Certificate of Appropriateness

41 N Roby Rd

February 15, 2021

Proposed Work

PORCH- SIDE ELEVATION

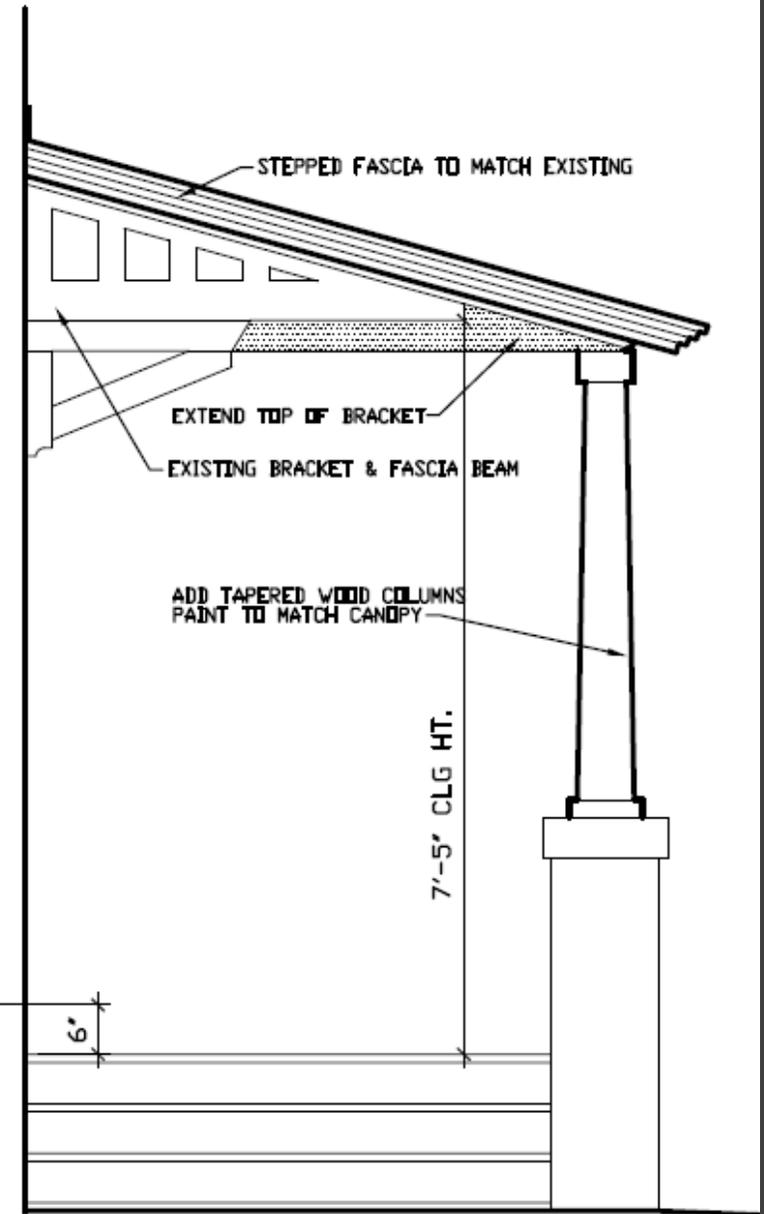
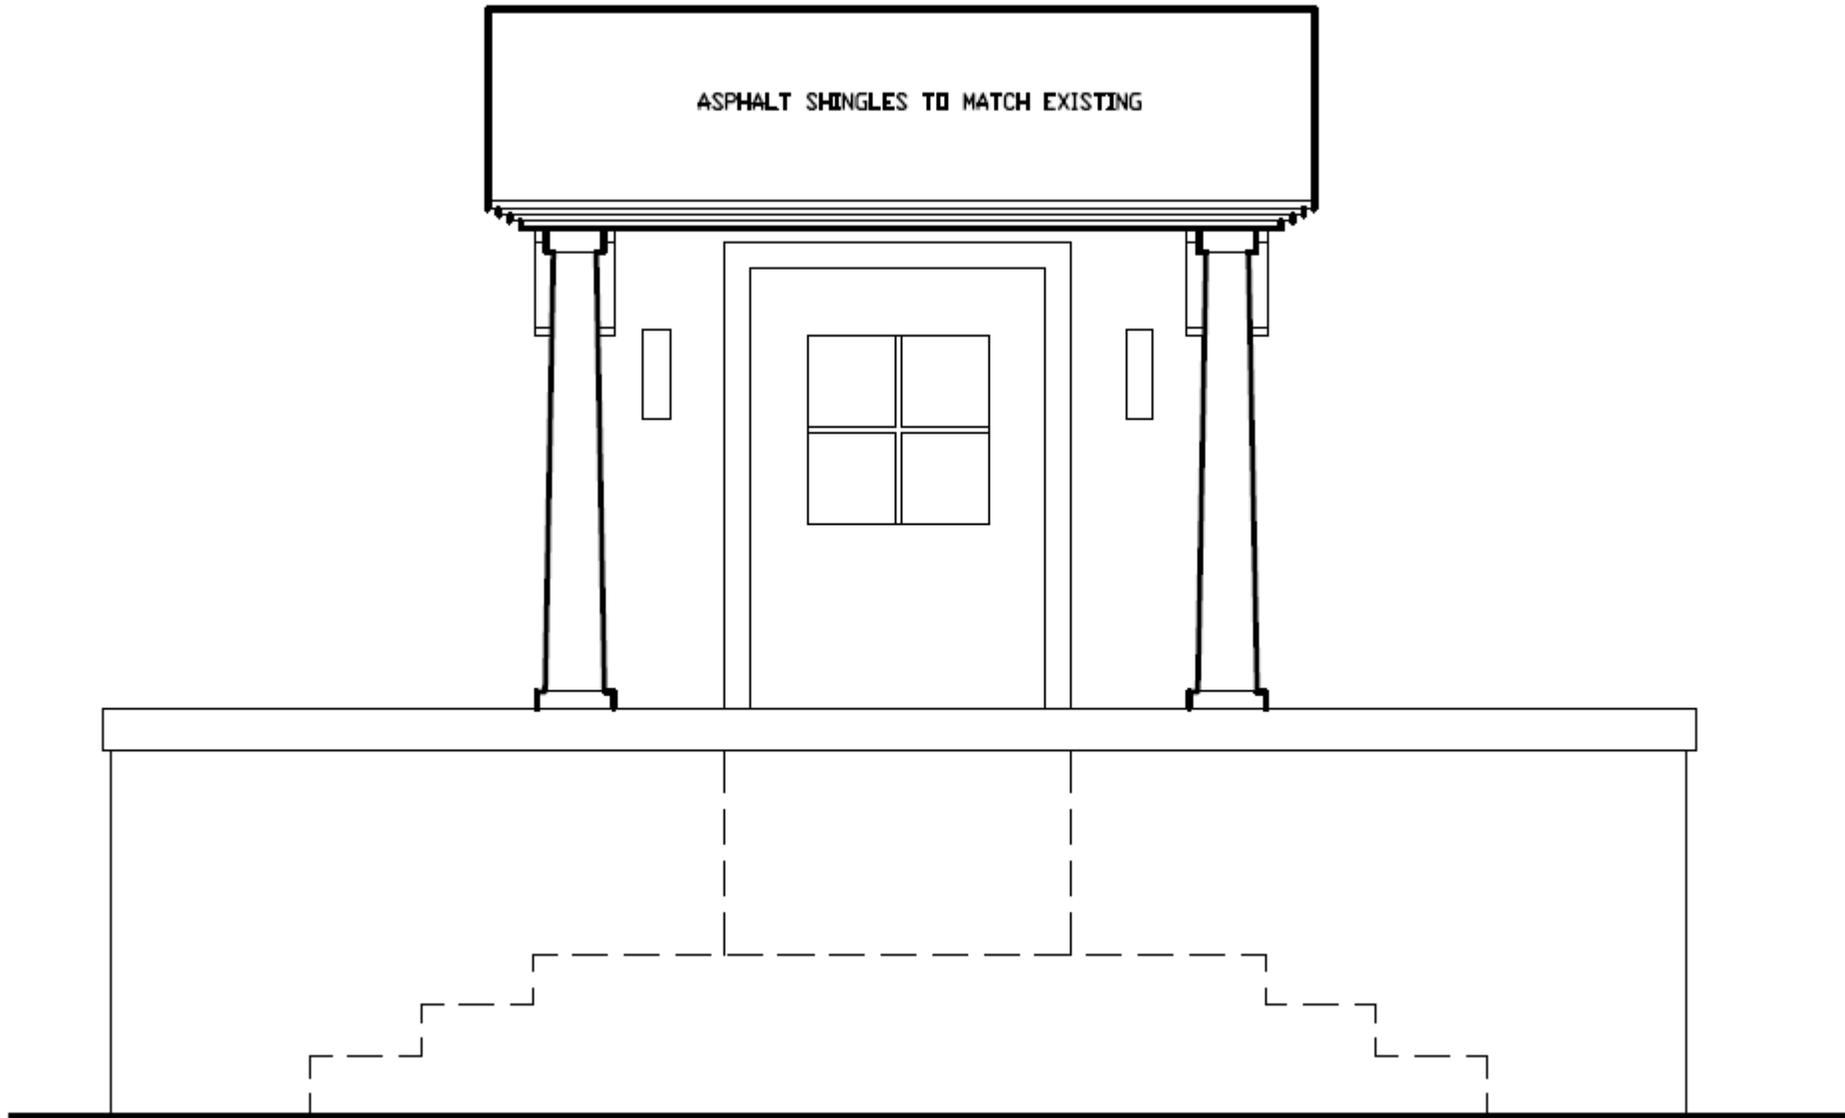
Staff believes that the standards for granting a Certificate of Appropriateness could be met. The Landmarks Commission should evaluate if the proposed alteration to the entryway meets the standards or if the cantilever should be maintained by introducing additional support to the interior.
